ENGINE - HP TURBINE ROTOR AND STATOR ASSEMBLY - PROVIDE A NEW STAGE 1 TURBINE HUB -  
CATEGORY CODE 8 - MOD.ENG-72-0238

Provide a new Stage 1 Turbine Hub that is redesigned to reduce operating stresses in the more severe operating conditions of the higher thrust V2500-A5 and V2500-D5 engine models. This first stage hub will become the new standard for all V2500 engine models.

V2500-ENG-72-0238

Location of the Stage 1 Turbine Hub  
Fig.1

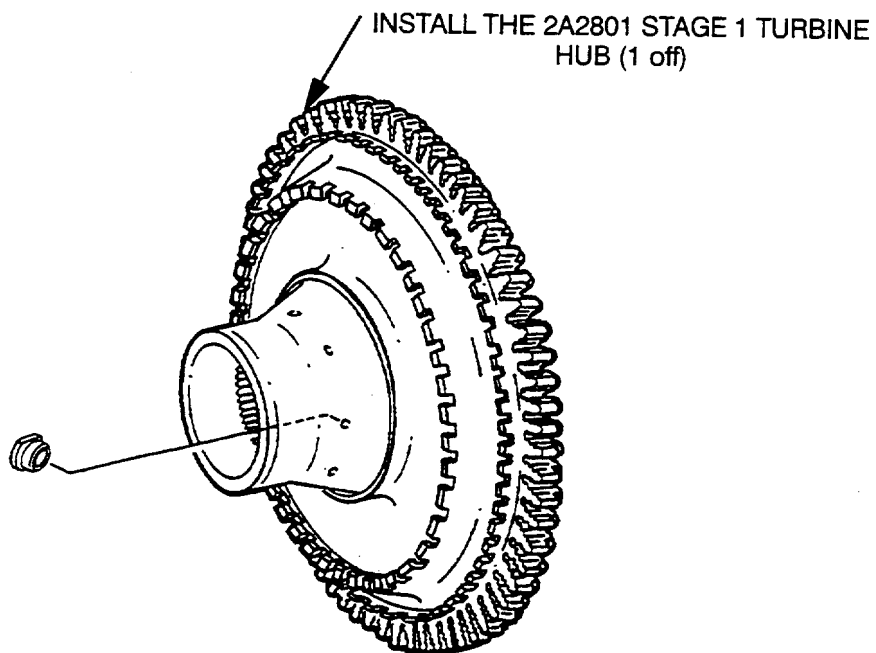
- (1) Replace the Stage 1 Turbine Hub with one that is designed to operate in the new higher thrust versions of the V2500 engine.
- (2) For the effect on declared life, See Appendix 1 of this Service Bulletin. The limits given in this Appendix will be included as soon as possible in revisions of the V2500 Engine Manual (E-V2500-1I-A) and the V2500 Engine Manual (E-V2500-3I-A).

- (1) Install the 2A2801 Stage 1 Turbine Hub by the procedure given in Reference (5), Chapter/Section 72-45-10, Assembly.

- (1) Install the 2A2801 Stage 1 Turbine Hub by the procedure given in Reference (6), Chapter/Section 72-45-10, Assembly.

Family Tree - Stage 1 Turbine Rotor Assembly Ref. Catalog Sequence No 72-45-10. Fig. 01 Item 010  
Fig.2 (Sheet 1)

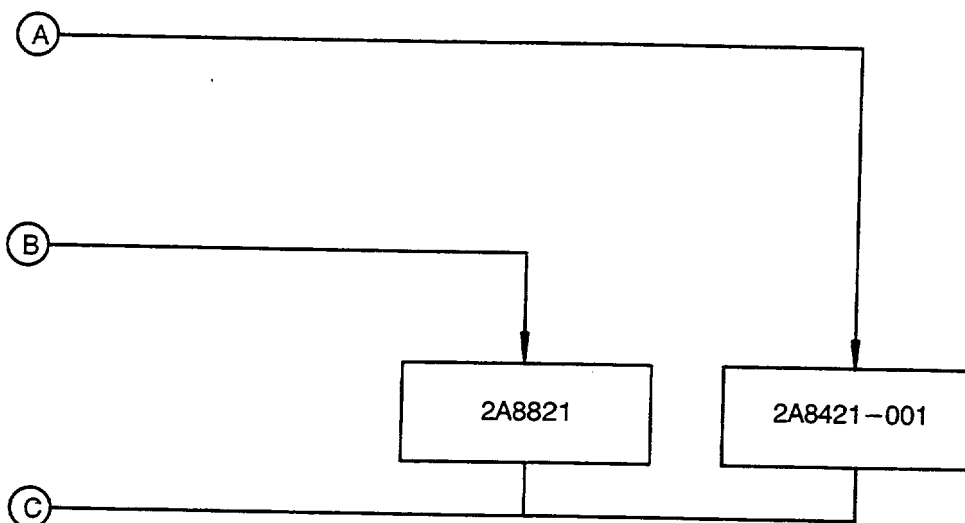
IT IS NOT NECESSARY TO IDENTIFY THE ROTOR ASSEMBLY WITH A NEW NUMBER. THIS PART PROGRESSION IS SHOWN FOR INFORMATION ONLY

2A3301 (72-45-10)	1		Turbine Rotor Assembly	2A8921 (01-010)	(A)(B)(S1)
2A2801 (72-45-11)	1		Hub Turbine Stage 1	2A2201 (01-011)	(B)(C)(S1)
